**Lake Monona Waterfront
Design Challenge
City Technical Team
Review Comments
3/15/2023
Revised: 3/29/23**

Proposed Law Park Design

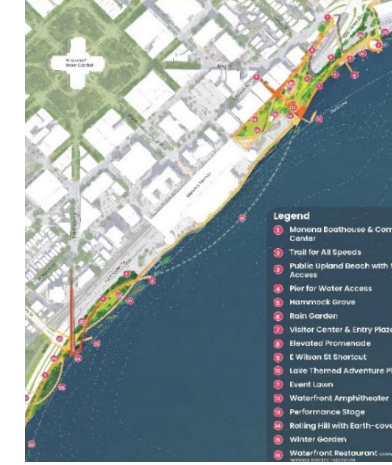
<p>The proposed roadway design in Law Park, north of the Monona Terrace, omits access to the Machinery Row parking lot. The private lot is the off-street parking and delivery location for Machinery Row businesses.</p>	<p>The proposed beach near the Broom Street intersection is along a historically-filled shoreline and the lake bottom drops steeply. This condition requires non-swimmers to stay close to shore.</p>	<p>The proposed pedestrian overpass at the Broom Street intersection will likely obstruct views of the Capitol from the lake shore. It will also provide a jump platform into the lake.</p>
<p>The proposed King Street extension requires removal and redevelopment of three privately-owned properties (155, 307, and 327 E. Wilson Street).</p>	<p>The proposed King Street extension requires removal and redevelopment of three privately-owned properties (155, 307, and 327 E. Wilson Street).</p>	<p>The proposed decking over John Nolen Drive north of the Monona Terrace will obstruct two floors of existing condominium units at 155 E. Wilson Street.</p>

<p>The King and Hamilton Street pedestrian overpass structures may create jump platforms into the lake.</p>	<p>It appears the proposed development of Law Park north of the Monona Terrace does not include an access ramp for emergency boat services (identified in the Preliminary Report).</p>	<p>The route of the multi-use path south of the Monona Terrace isn't clearly defined.</p>
<p>The proposed Monona Hill appears to show that people on bikes would need to ride up it to stay on the path. Many people on bikes will not want to ride up the path and will instead use the boardwalk unless they are heading to MLK (which seems like it will connect). Recreational riders will likely want to stay along the water especially visitors.</p>	<p>The proposed decking over John Nolen Drive north of the Monona Terrace will obstruct two floors of existing condominium units at 155 E. Wilson Street.</p> <p>The proposed beach at King Street conflicts with an existing fishery habitat (identified in the Preliminary report. The design and extent of the beach area must avoid disturbing this sensitive environmental system.</p>	<p>It is not clear if the Visitor Center & Entry Plaza bridge is high enough to clear the railway line. It also appears to have a large stair with no accessible route.</p> <p>The proposed beach north of the Monona Terrace conflicts with an existing fishery habitat (identified in the Preliminary report. The design and extent of the beach area must avoid disturbing this sensitive environmental system.</p>

<p>Some of the graphics seem to show that people will both walk and bike on separate paths on Monona Hill & the waterfront area is for "strolling" so not sure what that means for usage. There does seem to be a lowered path as well in a graphic but not sure how that would work. Is it in the tunnel? What would that be like - motor vehicle fumes might be a real concern.</p>	<p>Removing John Nolen Drive vehicle lanes north of the Monona Terrace will cause significant disruption to traffic flow, given current traffic volumes.</p> <p>The plan does not provide the pork chop island at Williamson St. A previous study explored omitting the island, and there were problems with not being able to separate the pedestrian walk indication from the right turn signal. The King Street pier structure may create a jump platform into the lake.</p>	<p>The elevated waterfront park concept is interesting but wonder how this would work from a walking/biking perspective as well as accessibility.</p> <p>The Overlook at Hamilton street could become a jumping platform into the lake.</p>

Proposed Law Park Design (cont.)

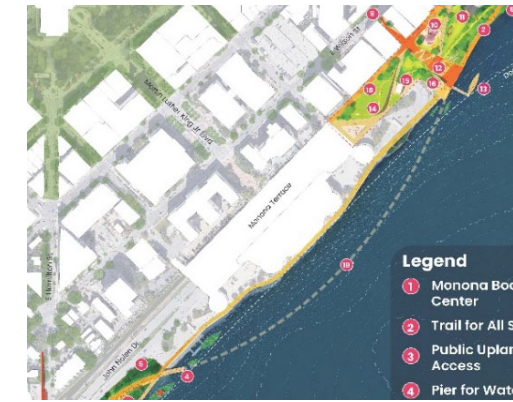
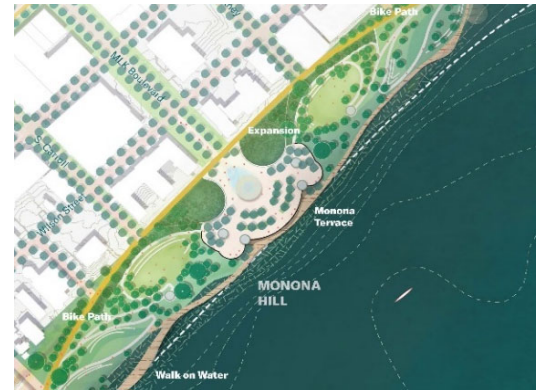
Agency Landscape + Planning	James Corner Field Operations
<p>Will there be an easy way for people on bikes to reach the overlooks and sitting space without creating additional conflicts? Will there be space for people to park their bikes to enjoy those amenities or would then need to park at either end of the causeway to do that?</p>	<p>Broom St cul de sac - need to ensure that the path crossing is well designed so that people driving in to pickup or drop-off (especially people from out of town) are yielding and driving safely.</p>
<p>Will need to ensure the overpasses work for flow both on/off and through the area as the transitions can be tricky. The graphic shows lots of different potential movements that would need to be well thought out to minimize conflicts between users as someone will be just moving through and others will be just looking around enjoying the views and trying to figure out where they want to go.</p>	<p>Like the idea of improving and separating the fishing area near Lake Monona although this approach may have some challenges and logistical issues</p> <p>It is not clear how the footbridge at Hamilton St is envisioned to work - is there an elevator down? How will it be accessible? How are bikes accommodated?</p> <p>The plan renderings extend beyond the project boundaries, making the available area look larger than it is.</p>

<p>See Monona Terrace comments.</p>	<p>The connection to the proposed King Street pier includes multiple sets of stairs with no clear accessible route.</p>
	<p>The proposed dog run is on top of Madison Water Utility well #17, which is critical to the city water supply. Well and pump station access must be maintained with any proposed improvements.</p> <p>See Monona Terrace comments.</p>

Proposed Monona Terrace Changes

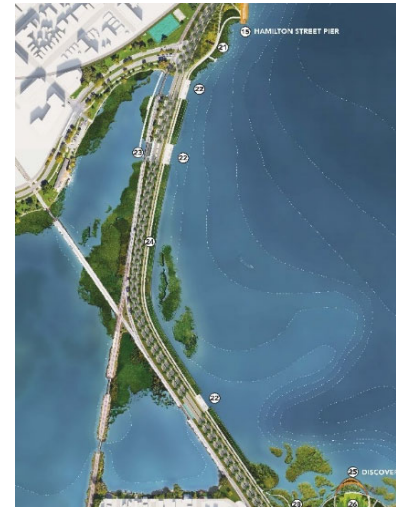
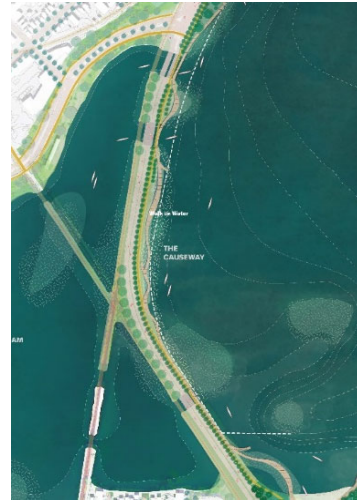
<p>Any proposed changes to the Monona Terrace are the purview of the Common Council per the recommendation of the Monona Terrace Board. The Monona Terrace is a Frank Lloyd Wright structure, and proposed modifications must maintain this designation. Any changes will likely require review by the Frank Lloyd Wright Foundation.</p>	<p>Any proposed changes to the Monona Terrace are the purview of the Common Council per the recommendation of the Monona Terrace Board. The Monona Terrace is a designated Frank Lloyd Wright structure, and proposed modifications must maintain this designation. Any changes will likely require review by the Frank Lloyd Wright Foundation.</p>	<p>The proposed master plan works with existing Monona Terrace and accommodates the future expansion zone.</p>
<p>The hill greatly detracts from the signature Monona Terrace and the iconic view ("postcard view" as it is called in the Downtown Plan). It covers too much of the building and seems to visually disconnect it from the Downtown.</p>	<p>It appears the proposed the fishing platform at lake-level extends beyond the State-determined limit for shoreline improvements (Buildable Dockline per the Preliminary Report).</p>

<p>The steepness of the hill will likely make many parts of the area inaccessible. The Bike/pedestrian overpasses down Hamilton/King back up the rear of Monona Terrace are confusing (They seem to go down and then back up to the center of Monona Terrace which would be more easily accessible from MLK Jr. Blvd)</p>	<p>The wall along the bike path helped protect the first floor of the Terrace from flooding in 2018. Pumps and sandbags were placed at the end of the wall to keep flood water from entering the facility. The proposed design removes this feature.</p>	
<p>It appears the proposed multi-use path requires users to climb up to the Monona Terrace elevation and then back down again.</p>

**Proposed John Nolen Drive -
Northshore Drive to Lakeside Street
Design**

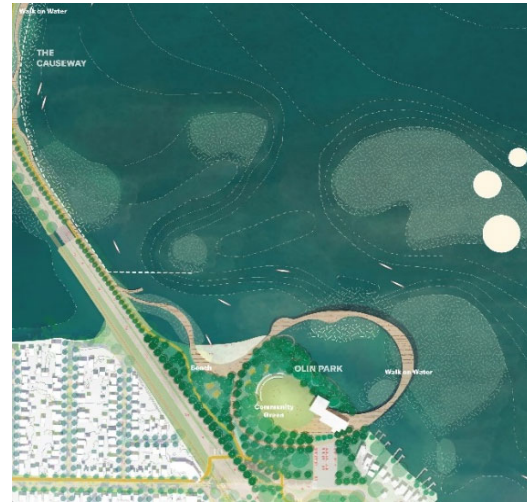
Agency Landscape + Planning	James Corner Field Operations	Sasaki
<p>The proposed master plan works with current plans for the reconstruction of John Nolen Drive and the Blair Street intersection.</p>	<p>The plan does not provide left turn lanes for north-bound John Nolen Drive to Northshore, or north-bound John Nolen Drive to Broom. These are major entrances to downtown and will need some type of accommodation for left turns.</p>	<p>The proposed master plan works with current plans for the reconstruction of John Nolen Drive and the Blair Street intersection.</p>
<p>The narrowed median is consistent with the public feedback received at the 02/23/23 PIM. The proposed master plan appears to work with current plans for the reconstruction of the John Nolen Drive causeway.</p>	<p>The proposed heavy tree planting along the causeway will block the iconic views ("postcard views" as stated in the Downtown Plan) of the capitol and skyline. The anticipated roadway median width is not sufficient to support full-size canopy trees.</p>	<p>The narrowed median is consistent with the public feedback received at the 02/23/23 PIM. The proposed master plan appears to work with current plans for the reconstruction of the John Nolen Drive causeway.</p>

<p>How will the new wetlands/marsh impact the overall walk/bike experience? Will it improve the health of the lake enough that this won't be an area where trash collects and where in the summer the lake has an unpleasant aroma? Want to make sure this is also an enjoyable experience year round.</p>	<p>The narrowed roadway median is consistent with the public feedback received at the 02/23/23 PIM. Note - the narrow roadway media increases the space along the causeway for pedestrians, cyclists, and shore access. However, it does not provide sufficient area for media trees. The proposed row of street trees isn't feasible with the anticipated roadway alignment.</p>	
	<p>How will the new wetlands/marsh impact the overall walk/bike experience? Will it improve the health of the lake enough that this won't be an area where trash collects and where in the summer the lake has an unpleasant aroma? Want to make sure this is also an enjoyable experience year round.</p>

<p>The propose footbridge along the causeway connecting people to Brittingham Park requires further evaluation. The proposed route under the causeway and railroad bridges will be below lake level.</p>

Proposed Olin Park Design

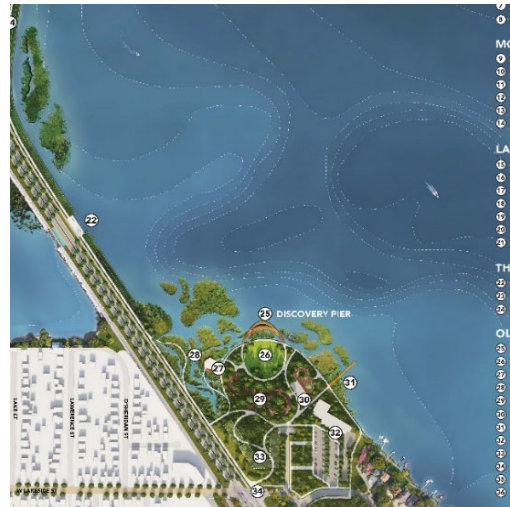
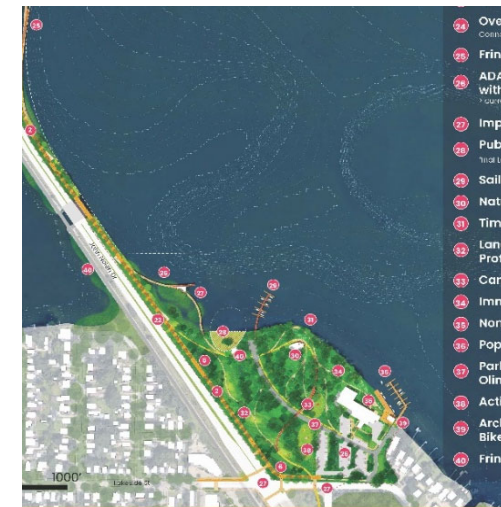
<p>The proposed circular boardwalk appears to prohibit watercraft access to it's interior and the park lakeshore. Lake Monona is a public waterway, and dock and boardwalk features cannot limit lake access.</p>	<p>The proposed "learn-to-kayak" course and islands are in a zone with very little lake current. Algae, floating vegetation and lake debris will collect in this area. There is concern the plan will create stagnant back water areas.</p>	<p>The proposed beach location at Olin Park is near an underwater shelf of submergent vegetation. The shelf is a fishery habitat zone, and the design and extent of the beach area must avoid disturbing this sensitive environmental system.</p>
<p>The proposed beach location at Olin Park is near an underwater shelf of submergent vegetation. The shelf is a fishery habitat zone, and the design and extent of the beach area must avoid disturbing this sensitive environmental system.</p>	<p>The proposed land reduction for the kayak course removes an iconic viewing spot of downtown Madison.</p>	<p>The proposed beach at Olin Park is in a zone with very little lake current. Algae and other lake vegetation accumulate in this area during the summer months.</p>

<p>The proposed beach at Olin Park is in a zone with very little lake current. Algae and other lake vegetation accumulate in this area during the summer months.</p>	<p>The proposed dock/boat rental location is at a very steep section of shoreline, with a 20 ft. plus drop to the water.</p>	<p>Like the concept of the tree canopy walk, but have concerns on feasibility. How is access provided? What are the connection points? Will it be available in winter?</p>
<p>Support the idea of having interpretive information along a path. This likely will also attract people on bikes especially families and visitors. Have concerns this will cause conflict/strife between users. Is there a way to make that work if people are biking slowly or would it just need to be signed for walking only and have good bike parking? That does raise issues over space to pull over and look at the signage if slow bicycle traffic is allowed.</p>

<p>The bike path and pedestrian path in Olin Park is one area where the paths diverge the most and there is likely to be people walking/biking on both. People walking may want a more direct path and people biking may want to visit the beach, the community green, the spectator space, etc. How is this envisioned to work? Also, the word "fast" is not a great choice since people biking, scootering, etc. are traveling at varied speeds and also have conflicts.</p>
